**From:** Cathy Brotherton  
**Sent:** 04 January 2022 16:37  
**To:** Hilary Saunders <  
**Subject:** RE: New application post - NYM/2021/0967/CVC - The Wilson Arms, Beacon Way, Sneaton - B Conservation

Project:  
**The Wilson Arms, Beacon Way, Sneaton, YO22 5HS**

Drawing:  
**Discharge of Conditions Details**

Drawing No: 2059/116A Rev:

WINDOW DETAIL

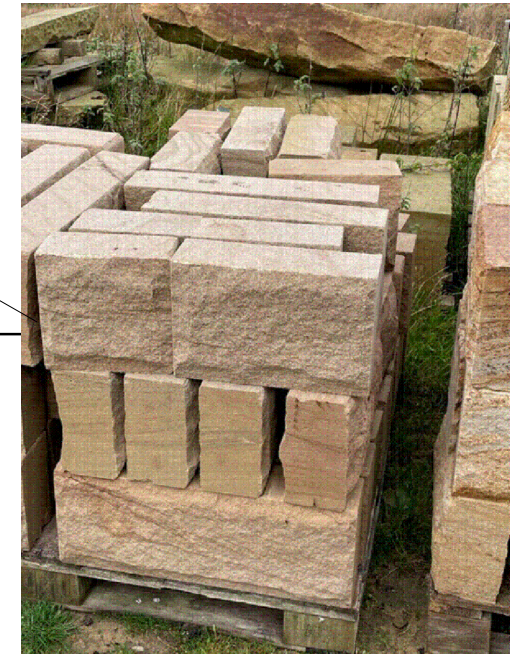
Condition 5 Windows and door details

Please provide sectional detail of windows to show structural glazing bars and slim-line units, currently it is unclear due to the scale what is proposed. However, the overall general appearance of 2 pane vertical sashes is acceptable. Standard 22mm IGU and plant on glazing bars are not typically supported in listed building (or extensions to) as they do not replicate the finial details of traditional joinery. We are however supporting of slim-line units of vacuum units that allow for finer joinery details in keeping with the buildings listed status.

Boarded doors, typically do not have a frame traditionally, can this detail be omitted?

Condition 5 – I have forwarded the plans to the joiner and will send further information once received

THE ROOFLIGHT COMPANY CONSERVATION  
ROOFLIGHT CR10-2

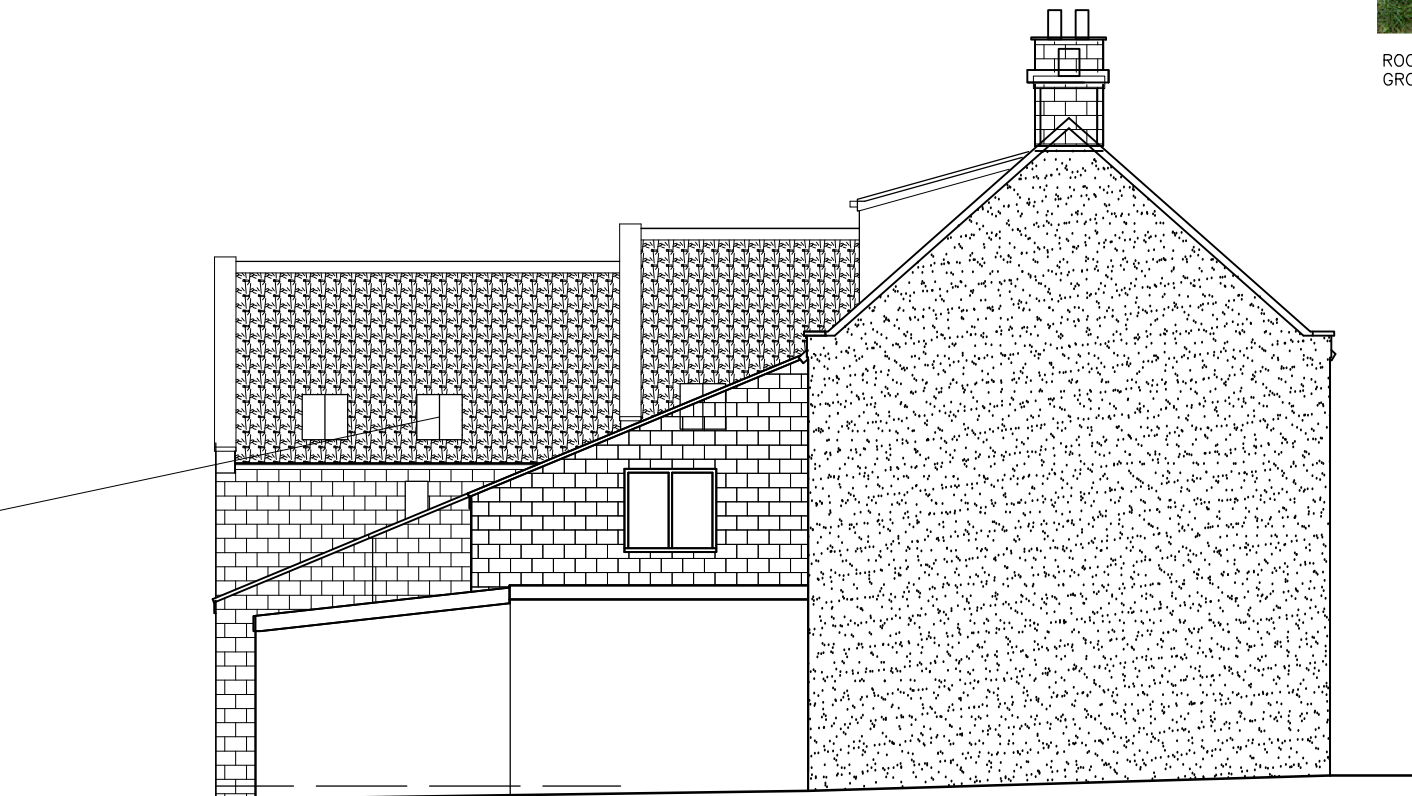
Condition 9 – please see updated plan showing an alternative rooflight which is metal – I hope this is more suitable

Condition 9 - Rooflights

This condition states that the rooflights be metal, those proposed are timber with a plastic coating and are not acceptable. The reason is that as they are of a timber construction they are overly bulky and do not replicate the proportions of traditional rooflights. Please amend this proposal, advice can be given if required.

A	30.12.21	Rooflights updated
Rev:	Date:	Notes:
